## **GROVE FARM**

### **TRANSPORTATION & HIGHWAY WRITTEN REPRESENTATIONS**

**HIGHWAYS ENGLAND  
DEVELOPMENT CONSENT ORDER APPLICATION (DCO)  
FOR  
M25, JUNCTION 28 IMPROVEMENT SCHEME**

**Redwood Reference: PMcL/3396d1/Feb 2021**

**Fig 1.0 Extract from Atkins HE Layout Plan TR010029/APP/2.7**

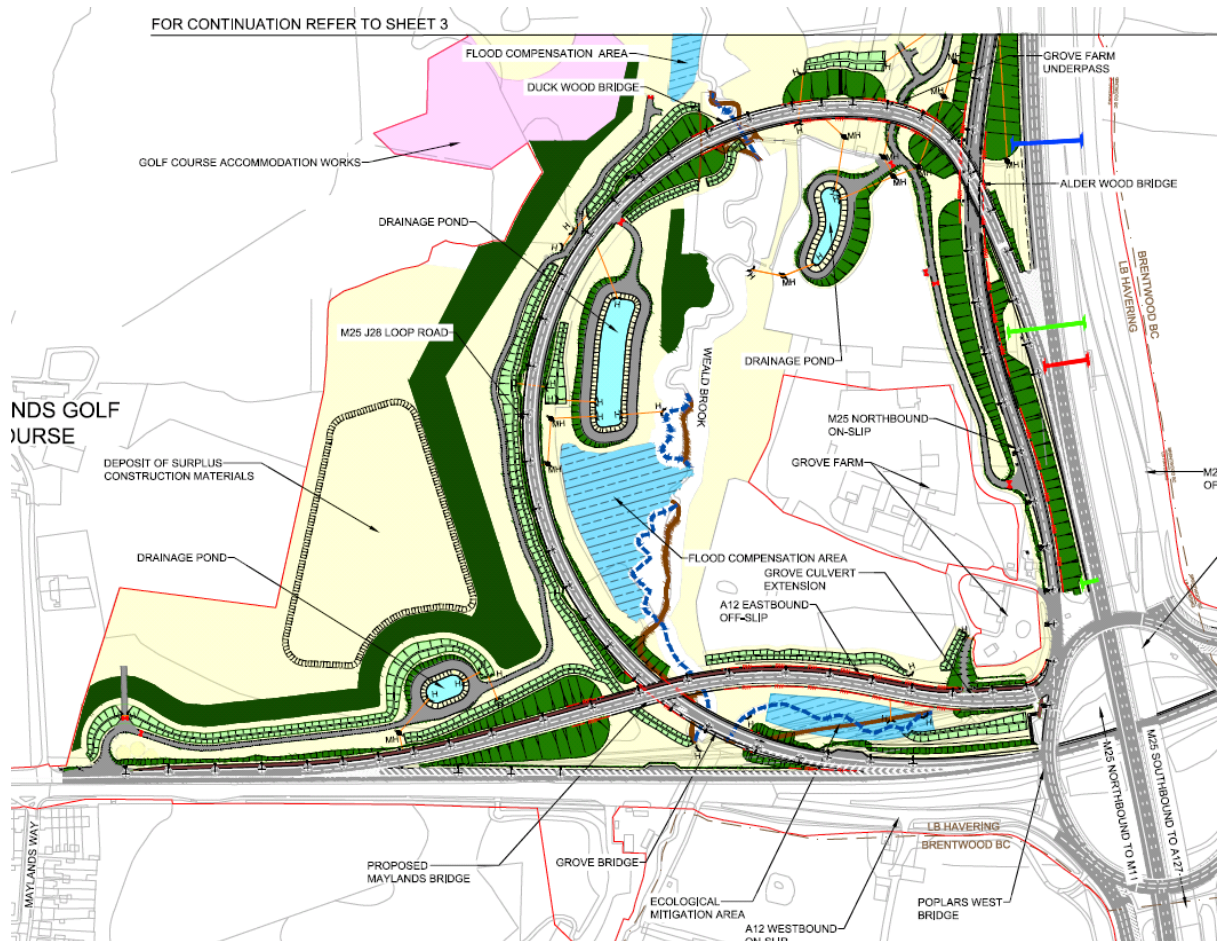
2.1 Grove Farm is the property mostly affected by the M25 Junction 28 Improvements Scheme. The HE Scheme has not considered any improvement to the location of the Grove Farm entrance from the M25 northbound on-slip. I understand that the HE consultants Atkins have worked from the beginning of the project on the basis that the access will be retained on a 'like for like' basis without any change or improvement. It is not clear from my discussion with Atkins whether this was a specific requirement of HE or whether this was just how the HE Scheme evolved.

2.2 In my opinion, the location of the existing Grove Farm access is already a material departure from highway design standards by its very location, being so close the north-west egress of the roundabout and its retention should be re-considered. The existing Grove Farm access in this location would not gain approval for any type of new development due to inherent safety issues. A point accepted by Atkins consultants.

2.4 The HE Scheme will introduce a further detrimental effect by moving the A12 eastbound on-slip give way line at the roundabout 25 metres further north-west, moving all crossing and

merging traffic travelling on the M25 northbound on-slip even closer to the existing Grove Farm access should it remain in its present location. This relocation of the A12 eastbound on-slip give way line will reduce even further an already sub-standard distance which vehicles have in order to manoeuvre and merge across lanes to access Grove Farm after leaving the roundabout. The Safety Appraisal (Section 3) also referred to this reduction in distance from the HE Scheme as exacerbating safety issues saying:

2.7 Given the inherent safety issues arising from retaining the Grove Farm access in its present location, I can see no practical reason why the relocation of the Grove Farm access could not be facilitated as shown on my **Drawing No. REDW-3396-111**. The proposed relocation of the access into Grove Farm will coincide with a vehicular access and egress point for pond and electricity board maintenance vehicles already proposed by the HE Scheme. The proposal will not introduce any new conflicting vehicle crossing movements.

Client		Project		<b>MR L JONES &amp; MRS K JONES</b> <b>GROVE FARM ACCESS, JUNCTION 28 M25 NORTHBOUND SLIP LANE</b>	
		Title		<b>SUGGESTED ALTERATIONS TO GROVE FARM HIGHWAY ACCESS</b>	
Status	Drawn	Scale	Sheet Size	Date	Drawing No.
FOR APPROVAL	PL	1:500	A3	JAN 2021	REDW-3396-111
				Rev

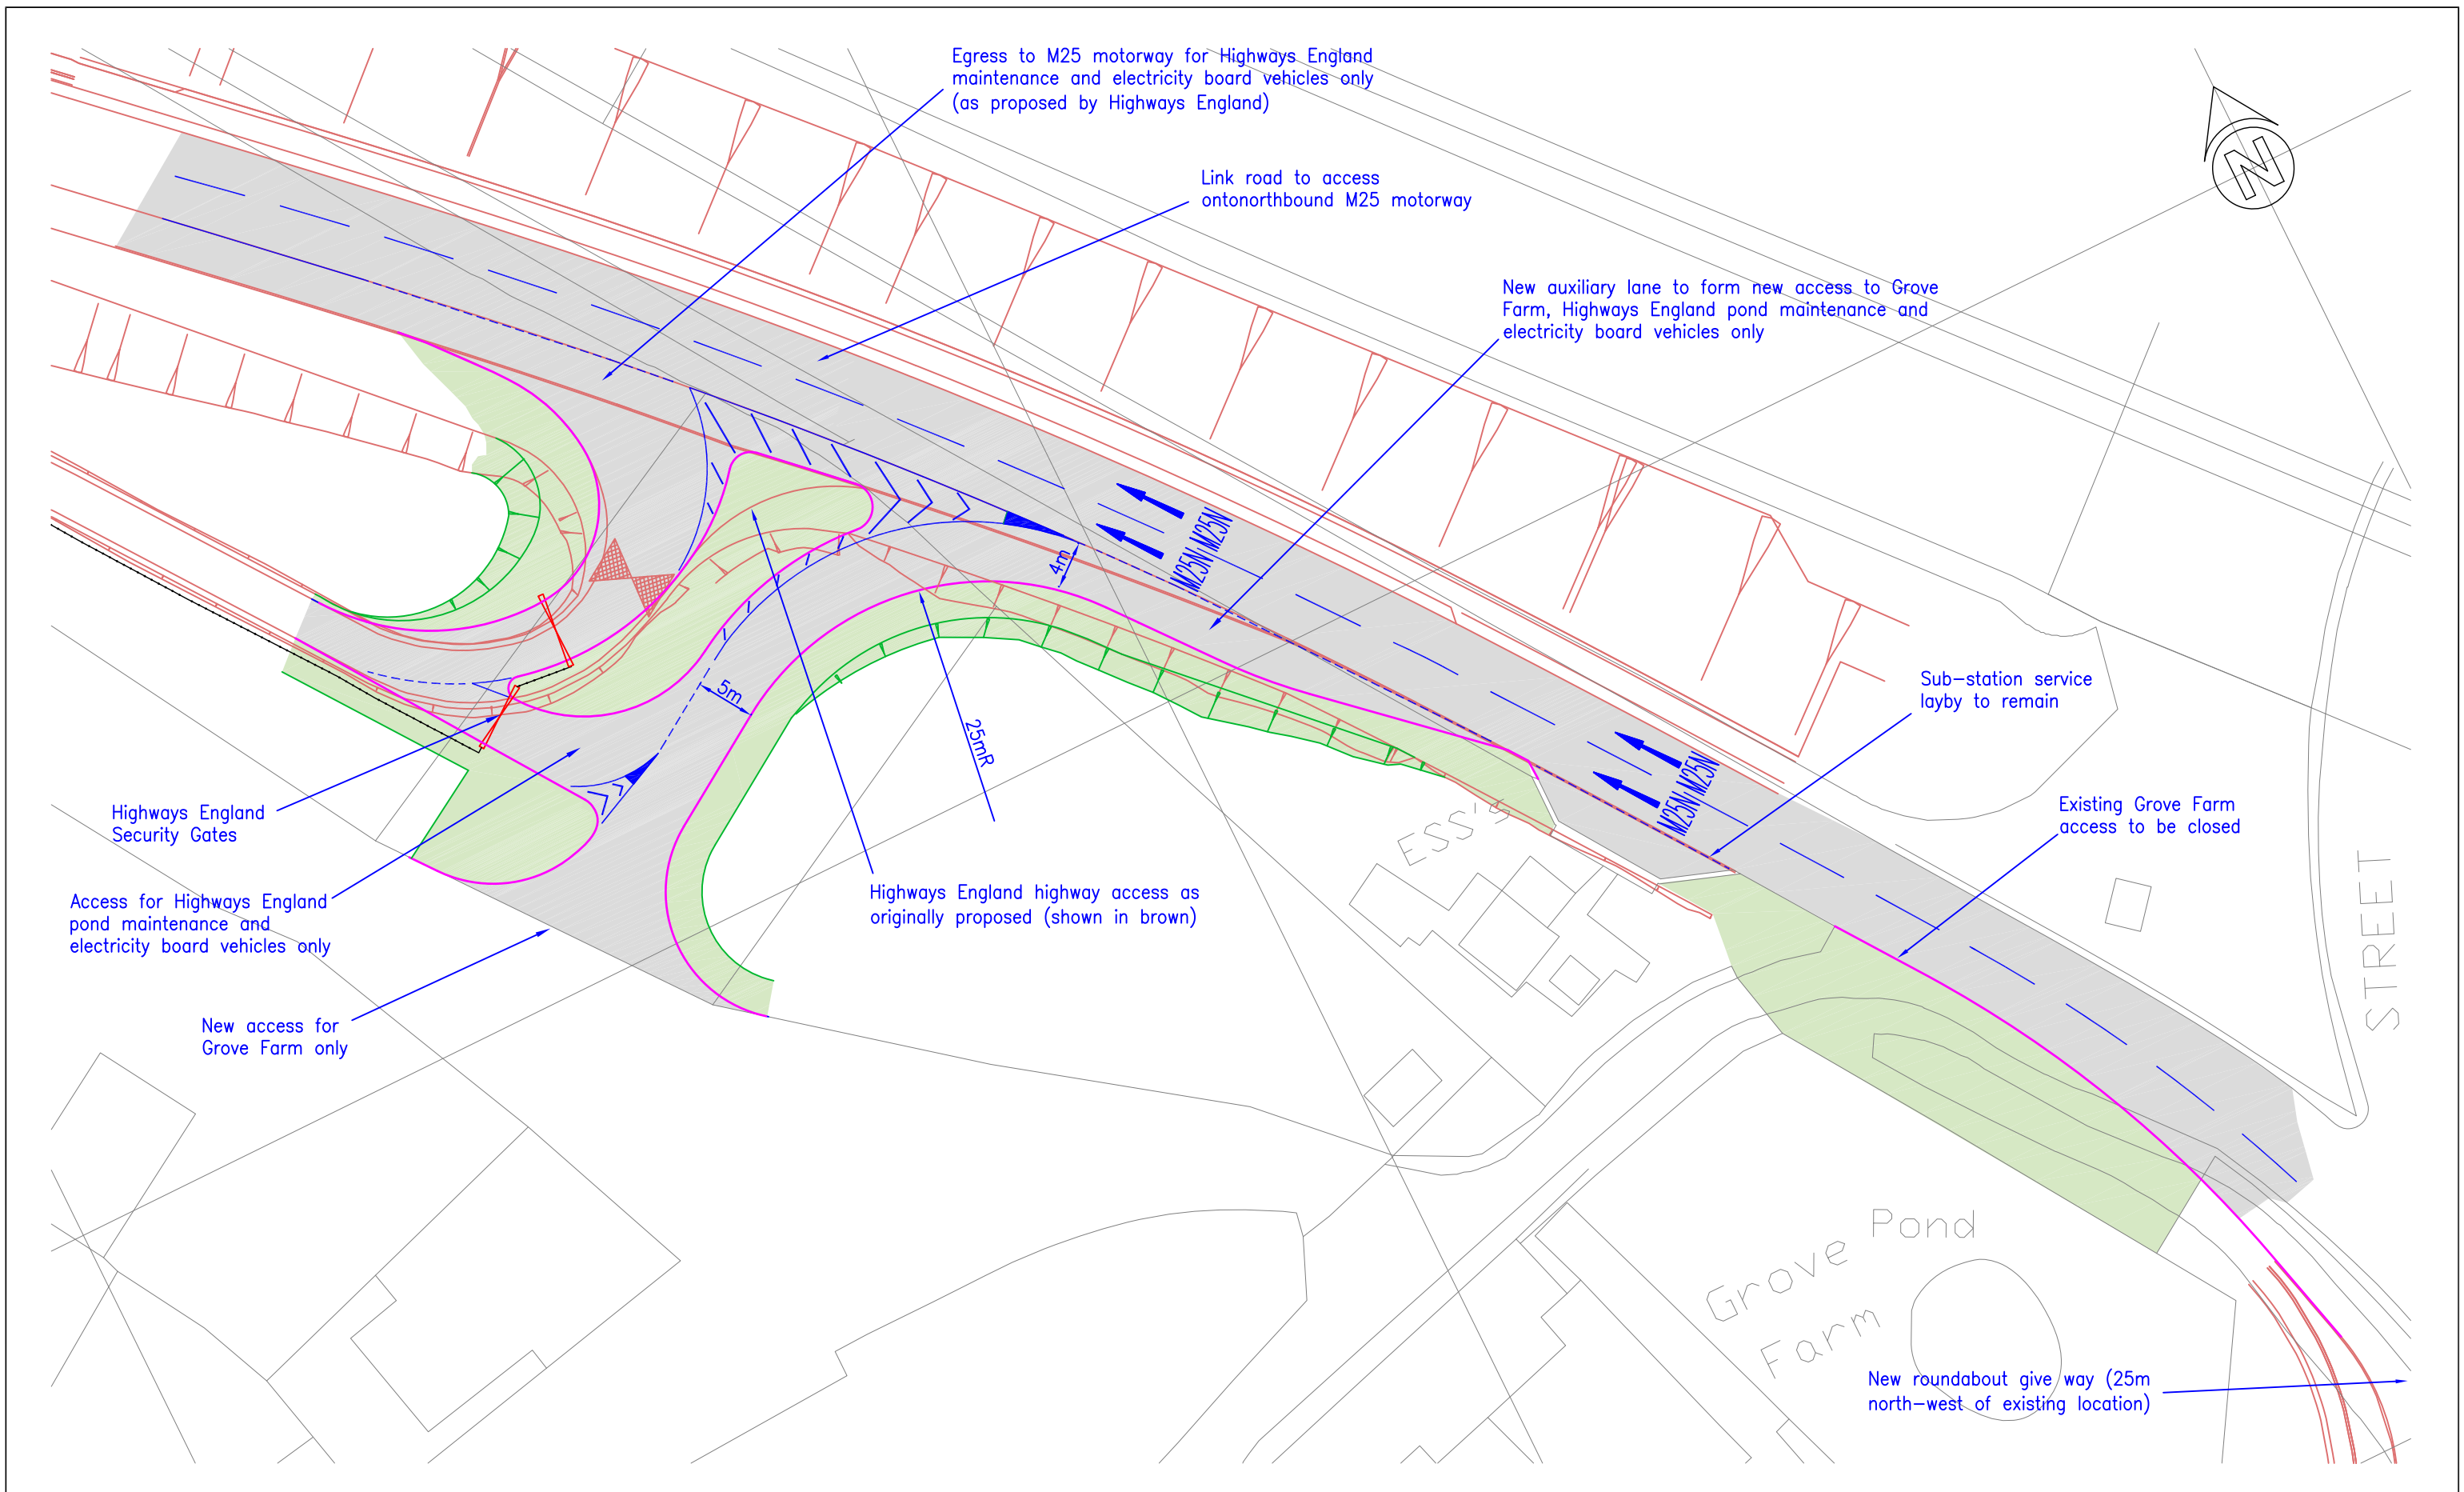
- 2.12 The new access proposal shown on my **Drawing No. REDW-3396-111** maintains a secure egress onto the M25 northbound on-slip for pond maintenance and electricity board traffic only. HE security fencing will prevent Grove Farm traffic leaving the site via the M25 northbound on-slip. Access will of course still be required by Grove Farm to their woodland area north of the proposed new loop road.

- 2.13 The clear benefits of the amended access proposal shown on my **Drawing No. REDW-3396-111** are as follows:
- i) The closure of the existing Grove Farm access will improve highway safety for Grove Farm and for the general public passing the site, removing an unsatisfactory entrance to Grove Farm;

- ii) The proposal will relocate Grove Farm traffic which currently passes close to the existing 3no dwellings on the farm. Relocating vehicles further north and away from the dwellings will reduce traffic noise;

- iii) The proposal will not introduce any new conflicting vehicle turning movements;
  - iv) The proposal will coincide with the location of the access already proposed by HE for pond maintenance and electricity board maintenance vehicles.

- v) The proposal introduces an auxiliary left turn lane in advance of the entrance, removing slowing traffic from the main carriageway accessing the M25 northbound on-slip;

2.15 We ask that HE consider positively and include the Grove Farm Access Proposals shown on my **Drawing No. REDW-3396-111** and presented within these Written Representations and amend their Junction 28, M25 DCO application proposals to include an amended vehicular access to Grove Farm to:

- i) Close the existing access to Grove Farm from the M25 northbound on slip road;
- ii) Provide a new dedicated auxiliary left-turn lane access to Grove Farm to be shared with the HE access already proposed for pond maintenance and electricity board vehicles.

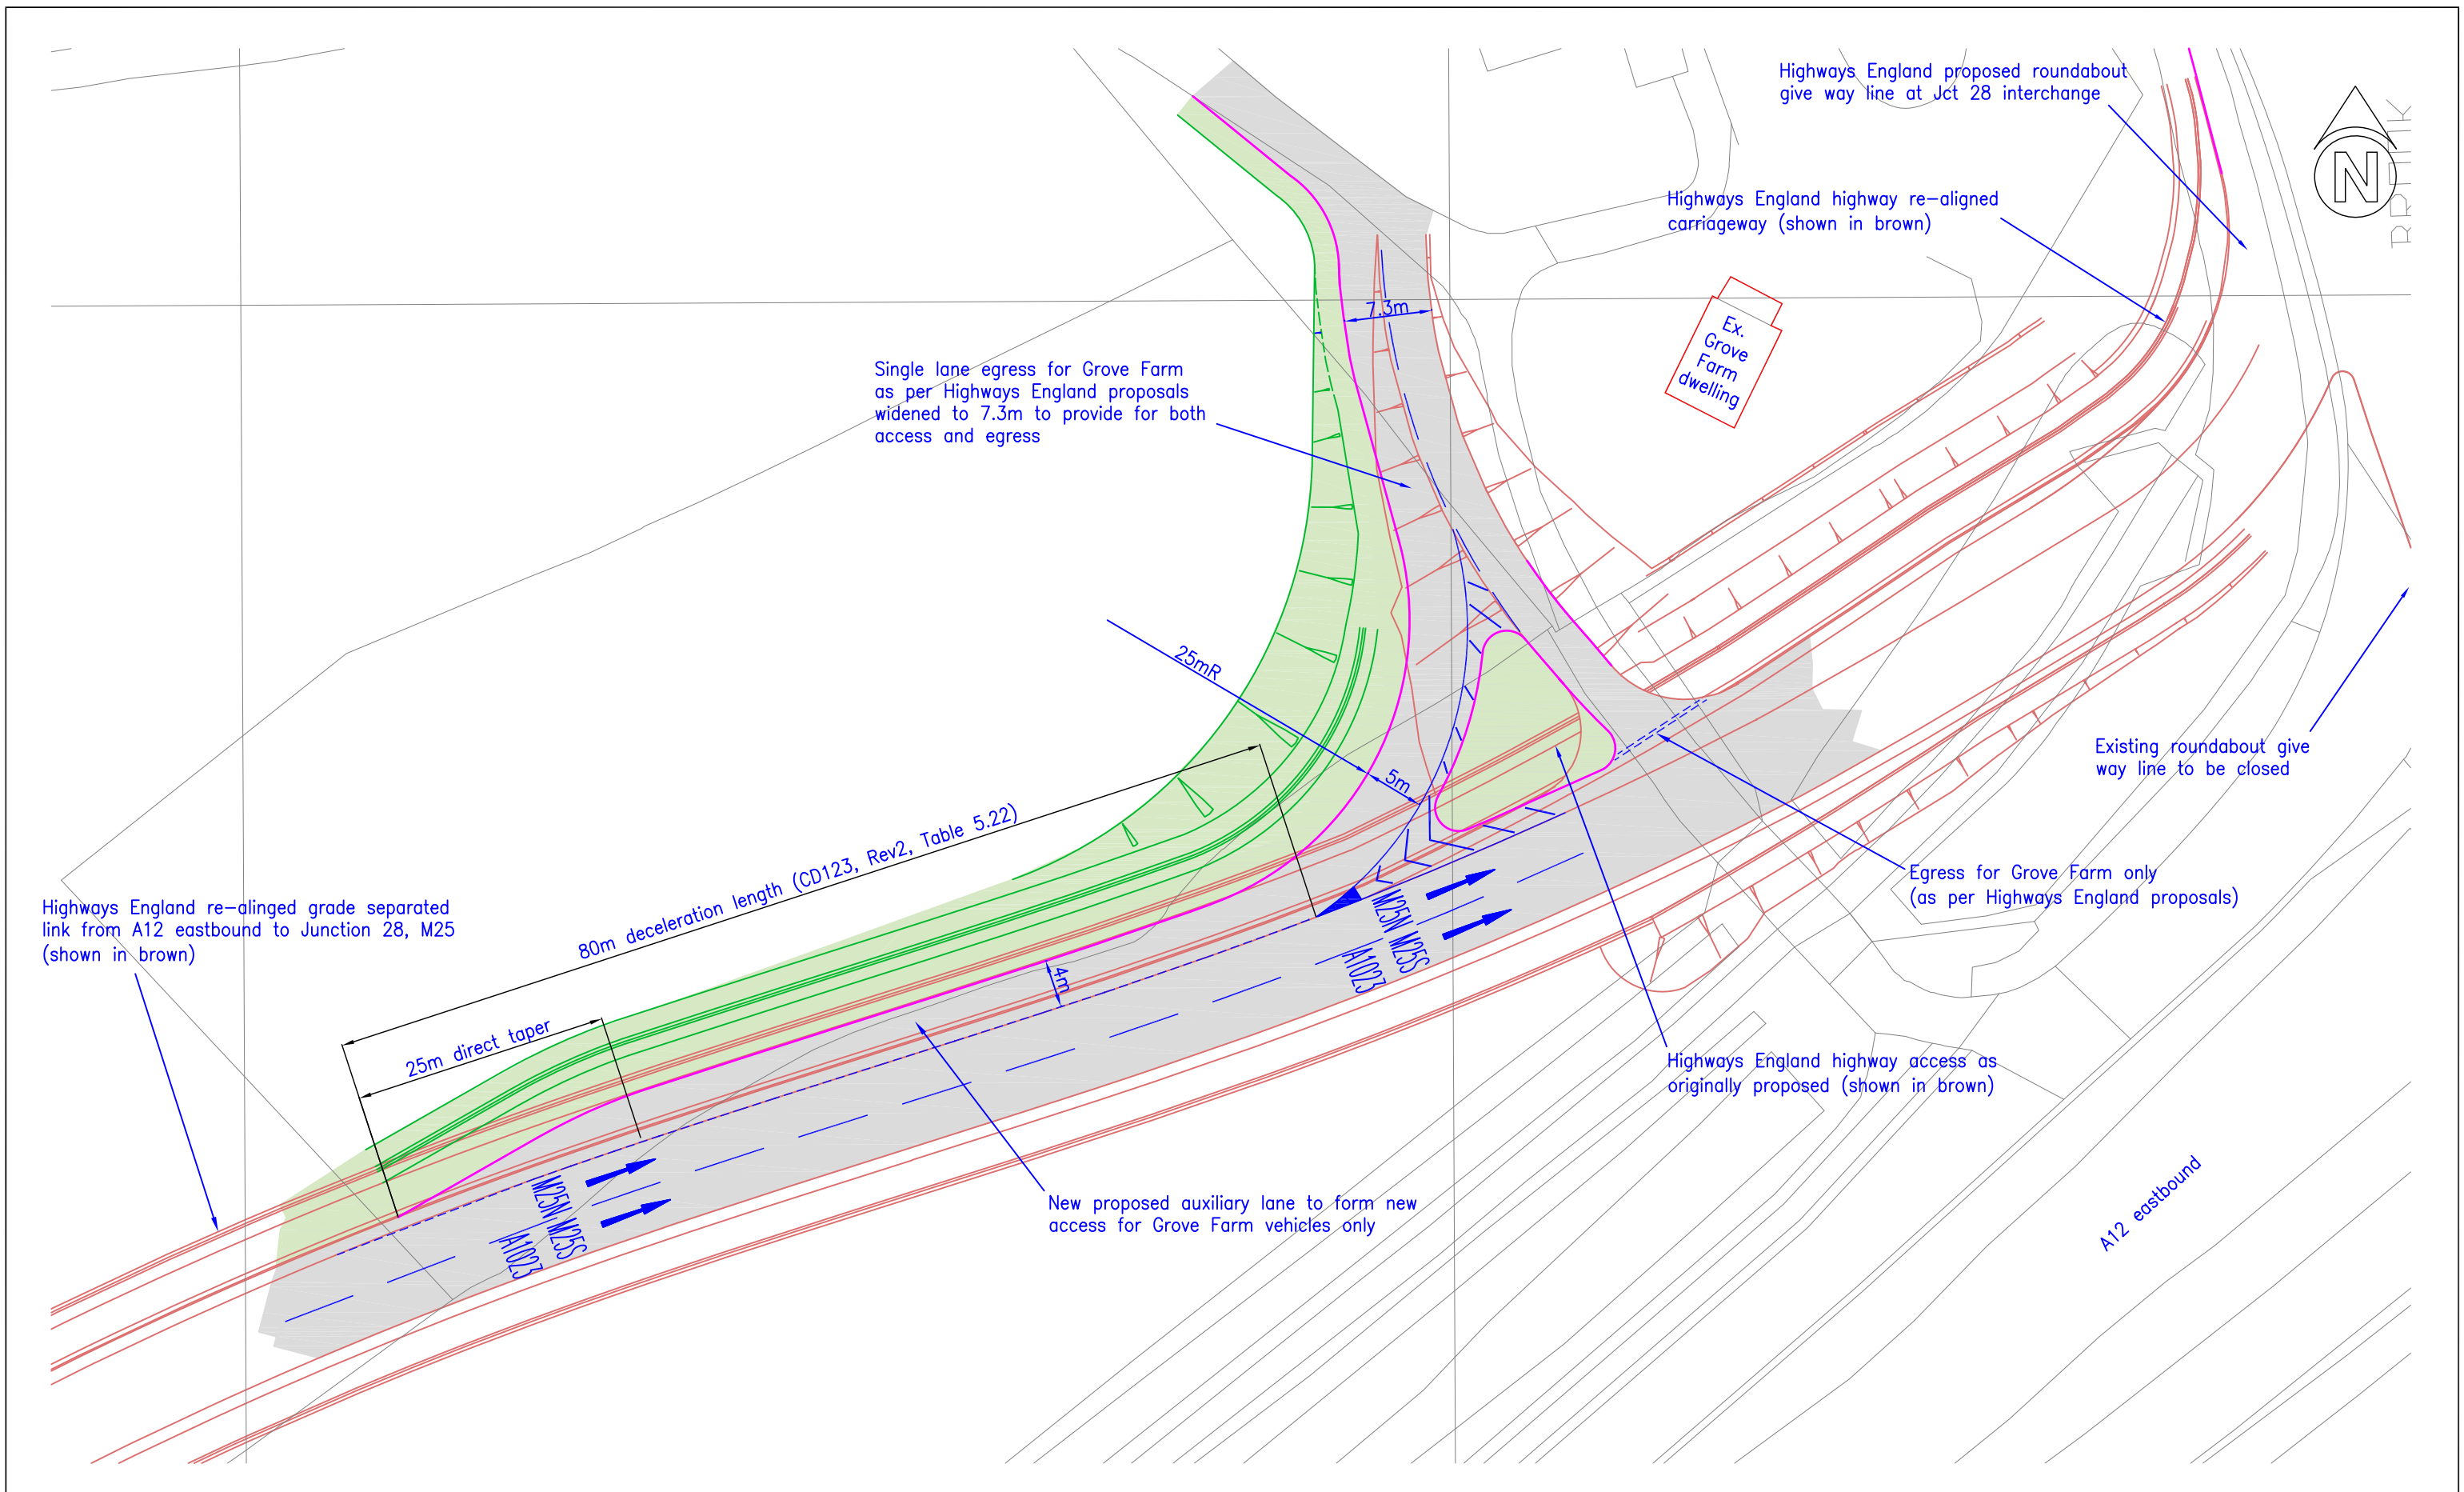
- 3.4 The Safety Appraisal (Section 4.2) highlighted that the length of the deceleration lane into Grove Farm for the proposed new site access off the A12 eastbound off-slip also has a shorter deceleration length which is a departure from design standards. It should be noted that the length of the deceleration lane shown can be extended to comply with design guidance as Grove Farm land is available for any extended works. Overall the audit team considered a new access into Grove Farm from the A12 eastbound off-slip as a significant improvement in road safety terms when compared with the existing deceleration lane provided on the M25 northbound on-slip and would reduce the number of vehicles accessing the site from the M25 northbound on-slip, stating:

*As part of the 'alternative' proposals, the site egress will become a site entrance and egress and a deceleration lane will be provided.*

*However, the proposed deceleration lane provided on the A12 off-slip at the site access is 80m long. As set out in 'CD 123 Revision 2', the minimum length of a nearside diverging taper or auxiliary lane should be 150m on dual carriageways.*

*The Authors of this report acknowledge that this deceleration lane is a significant improvement in road safety terms when compared with the existing deceleration lane provided on the M25 on-slip.*

*Furthermore, the revised access and provision of a deceleration lane on the A12, will likely reduce the number of vehicles accessing the site from the sub-standard access provided on the M25 on-slip.'*

- 3.6 The proposal shown on my **Drawing No. REDW-3396-112** has been subject to a Safety Review by the safety audit team. The highway safety consultant Mayer Brown raises no fundamental safety issues with regards the principle of the proposed amended access from the A12 eastbound off-slip.

- 3.7 The clear benefits of the new access proposal from the A12 eastbound off-slip shown on my **Drawing No. REDW-3396-112** are as follows:
- i) The proposal will remove Grove Farm traffic (in many cases large and slow-moving vehicles) from impacting on the roundabout when approaching the site from the A12 eastbound direction. Left turns to the site can be achieved prior to reaching the roundabout;
